PROPOSED TOWNSHIP DEVELOPMENT ON ERF 2642 AND PORTION 14 OF FARM 48, OPWAG, !KHEIS LOCAL MUNICIPALITY

COMMENT AND RESPONSE REPORT

(DENC Ref. No: NC/EIA/11/ZFM/!KHE/OPW1/2020)

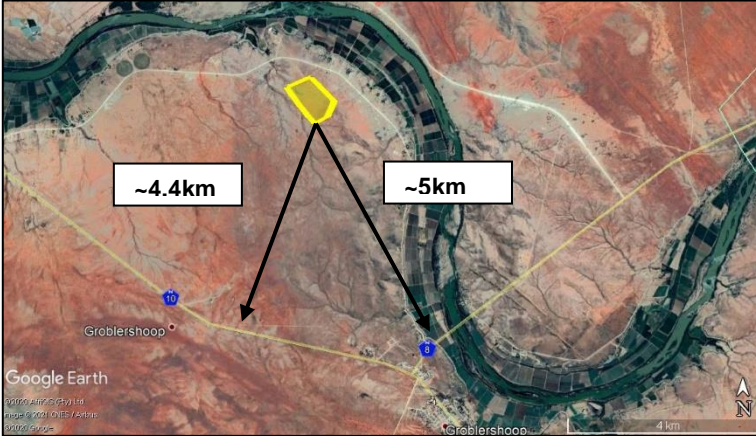
No.	Comment Date, Comment Format, Organisation/I&AP	Comment	Response from EAP/Applicant/Specialist/Project Manager
		<p>the holes into the bottom enclosed chamber, with a pipe that leads to a urine soak-away pit nearby. The faeces then dries out, needs to be raked to the back of the box from time to time and then the hard dry faeces needs to be collected after a year or more to be disposed of. The challenge with this system is that the holes can block and the angle is not steep enough for the faeces to slide down. They remain wetter longer and there is an extraction fan at the top of the chimney to eliminate most smells.</p> <p>It needs a full sun site, additional power for the extraction fan and people living higher might still get a whiff from the extraction fans, but the biggest deterrent is possibly the cost, it is more expensive. It is the best application for schools and community halls as seen in the photo below. The two glass tops are for the urinals. It is a very good method of coping with the urine. The urine dries into crystals. https://www.greenloo.org/enviro-loo-urinal.php</p> <p>2. URINE SEPERATION TWO CHAMBER SYSTEM</p> <p>a. An attempt is made to separate urine from faeces before the faeces drops down the seat. It is important for the success and acceptance of the systems to buy white high quality urine separation pedestals/seats. As can be seen in the photo below the system can be incorporated into the bathroom. It is advised to incorporation of a urinal against the wall in the blue bathroom picture as well. The urine can be collected in the same container the seat urine is diverted to.</p> <p>b. Build a two chamber system. Faeces are collected in one chamber until it is full, the seat is then removed and placed over the new empty chamber. The seal of the empty chamber is placed over the full chamber. The full chamber is left like it is until the second chamber is almost full. By now the faeces should be dried out. The dried out faeces is accessed through the sealed back wall and either disposed of or ground up and used as fertilizer in agricultural applications. The municipality can collect and dispose of the dried faeces.</p> <p>c. The selection of the site: It is vital for the optimal drying of the faeces that the back wall of the bathroom unit face North. To increase the absorption of the sun rays the back panel and the chimney should be</p>

No.	Comment Date, Comment Format, Organisation/I&AP	Comment	Response from EAP/Applicant/Specialist/Project Manager
		<p>Painted black or be manufactured from hard black plastic. Place a mosquito net above the chimney. The bigger the chimney the greater the up draft and reduced smell.</p> <p>d. The urine can be diverted to a soak away, or a solar evaporation site similar to the environ system or utilized in a diluted form in agriculture. It is important to be aware of the hesitance of local communities to use human waste in any form as part of a greater agricultural system and extensive community awareness activities should accompany such use.</p> <p>e. By placing a bucket of sand, ash or sawdust next to the toilet with a little scoop, visual unpleasantness and smell will be further reduced. In addition, the material like ash or sand can accelerate the drying time.</p> <p>f. Should flies find their way into the system, they would try to get out and the only light will be at the top of the chimney that is sealed with a mosquito net. The flies will then fly up and down the chimney until they die. It is highly unlikely if the seat remains closed.</p> <p>In the image above the toilet stool is a porcelain seat, that can also stand on its own, going straight downward without the u-trap of standard toilet seats. To the right on the photo is a urinal, for the use of men, with an outlet that joins the urine caught with the separate division in the seat. This photo was sourced from</p> <p>https://en.wikipedia.org/wiki/Urine-diverting_dry_toilet an example from Peru.</p> <p>This is what a urine separation seat can look like. The front chamber catches the urine and the dark blue is where the faeces drops down into the chamber. In this photograph there is a division that is not there. It is a pipe that have straight sides.</p> <p>This is local, South-African manufactured urinals on the market. It is advisable that the pipes should take the shortest route out, but protected from sun and damage.</p> <p>Additional resources:</p>
